2490.0 ORANGE LOT EXPANSION PHASE 4 UNIVERSITY OF KENTUCKY

RECORD DRAWINGS

2490.0 ORANGE LOT EXPANSION PHASE 4
UNIVERSITY OF KENTUCKY
LEXINGTON, KENTUCKY

INDEX OF DRAWINGS,
LEGEND & GENERAL NOTES

PAVEMENT TRANSITION
N.T.S.

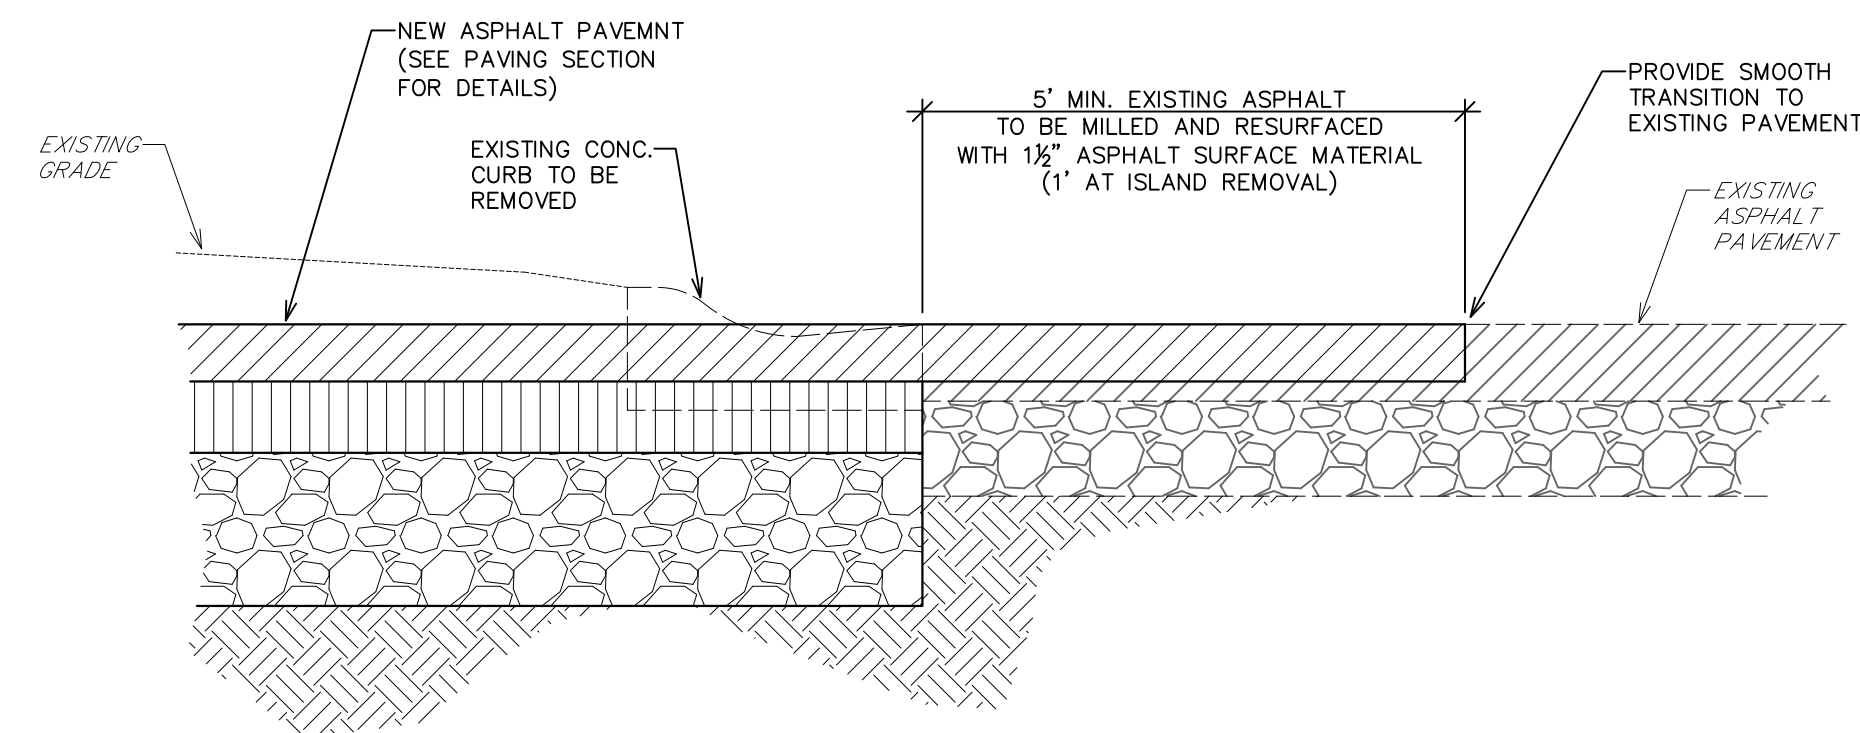
THIS DETAIL SHALL REPLACE THE ASPHALT PATH DETAIL SHOWN ON SHEET C31

SITE GRADING AND DRAINAGE PLAN

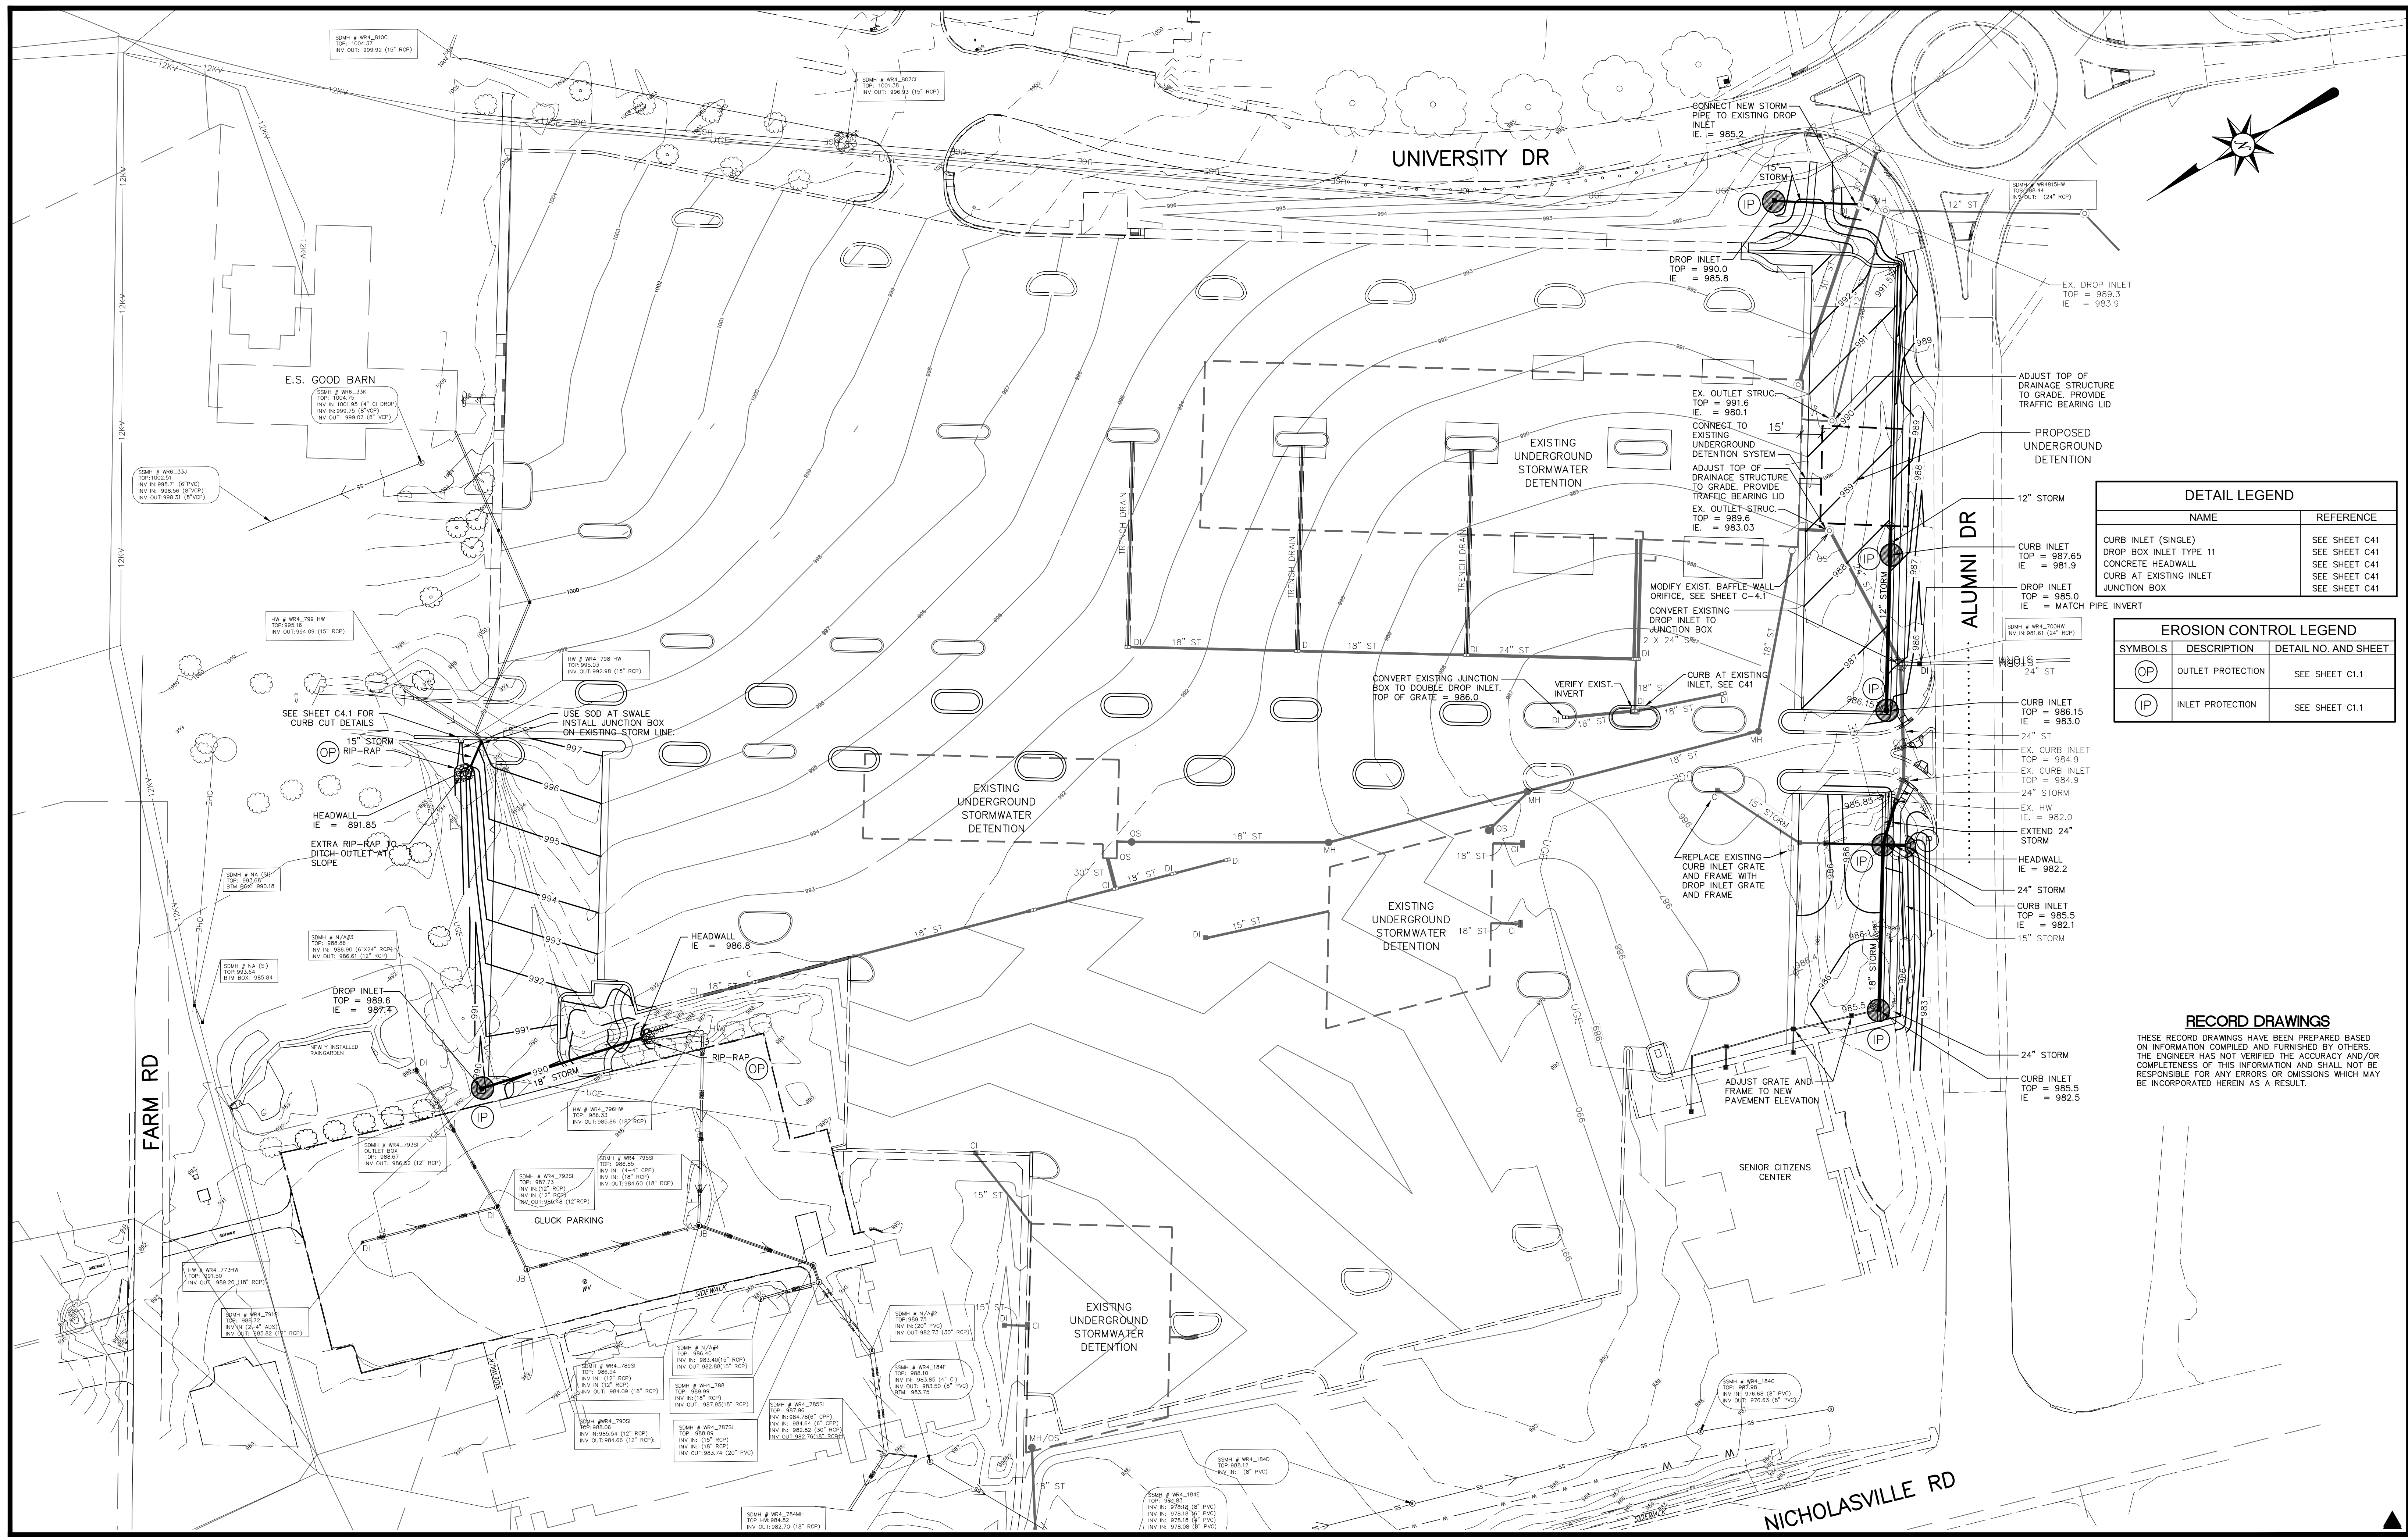
UNDERGROUND DETENTION
 TRENCH DRAIN
 ADJUST ISLAND WIDTH TO MATCH EXISTING STRIPING LAYOUT. FIELD VERIFY WITH PROJECT ENGINEER.

Project Name: U of K Orange Parking Lot Ph IV Dia. 30 Structure No. STORMTECH SYSTEM BASIN Qty. 1
 Prepared By: Nathan Tullis ADS/Nyloplast 678-745-6038 Nathan.Tullis@ads-pipe.com
 Accessories: 30; Solid;
 Rim Elev. 987.65 ft. Basin Height 103.56 in. Sump Depth 24.00 in.

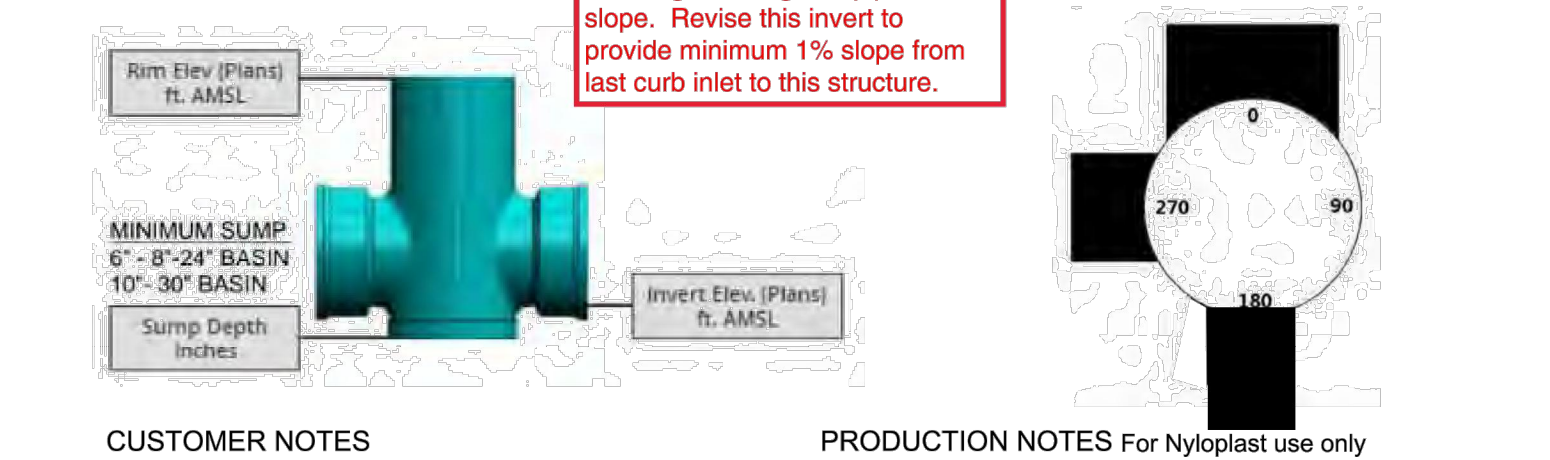
CUSTOMER NOTES
 VERIFY INVERT OF STUB #2 / VERIFY RIM

PROPOSED ELEVATIONS

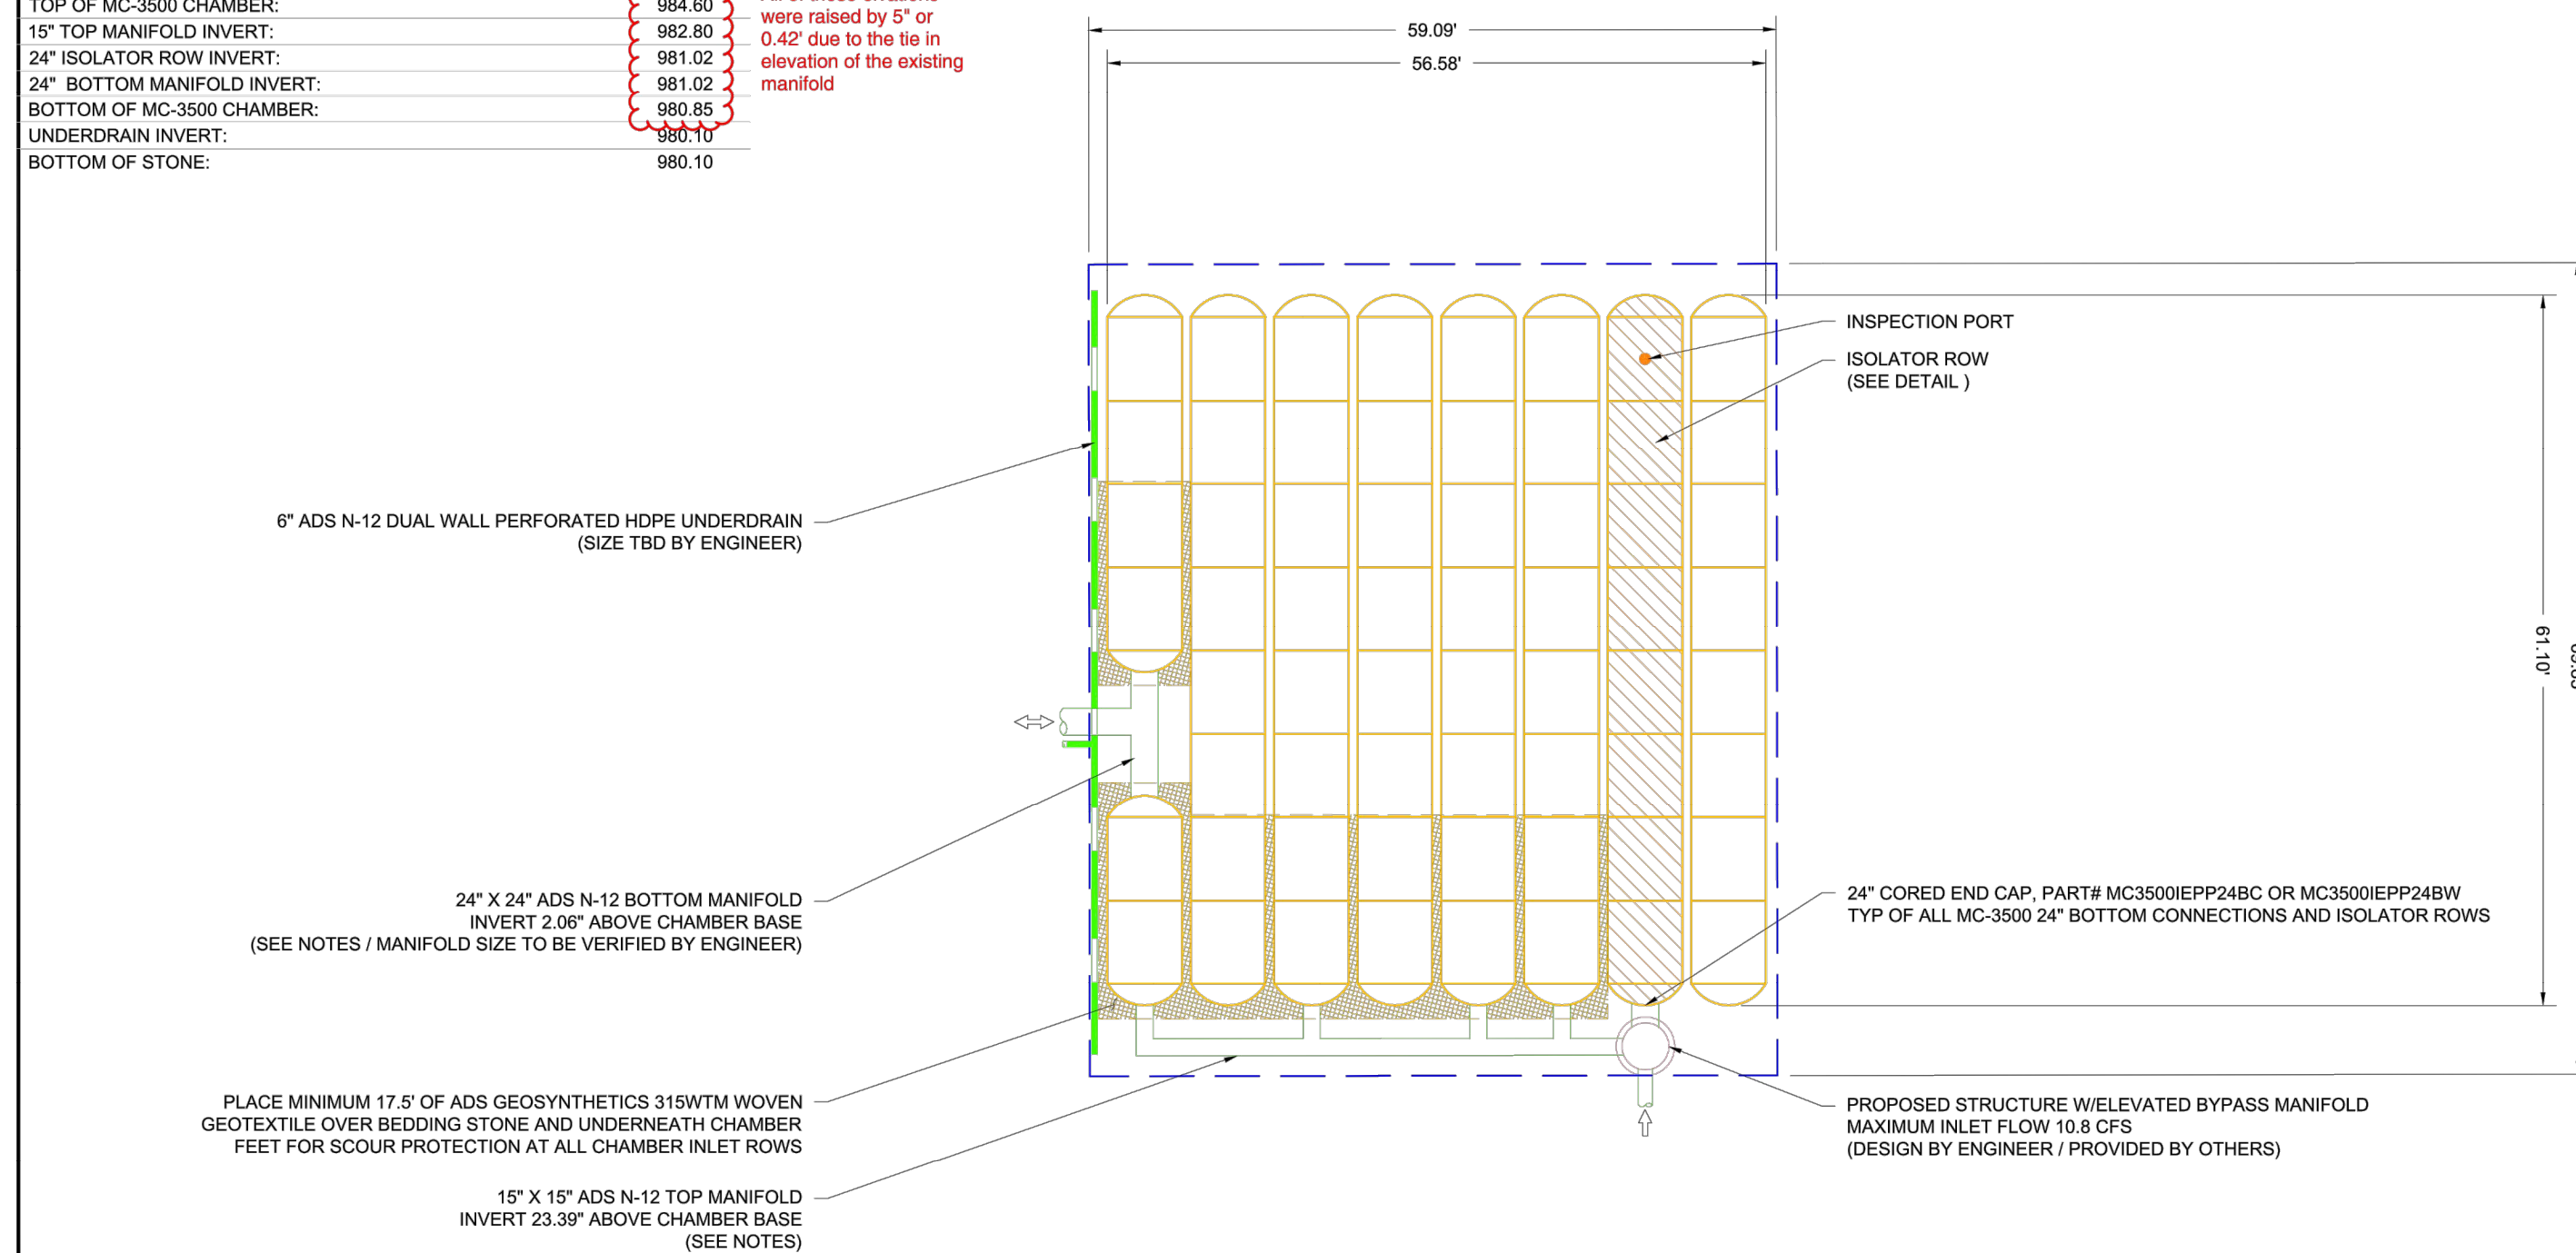
All of these elevations were raised by 5' or 0.42' due to the tie in elevation of the existing manifold
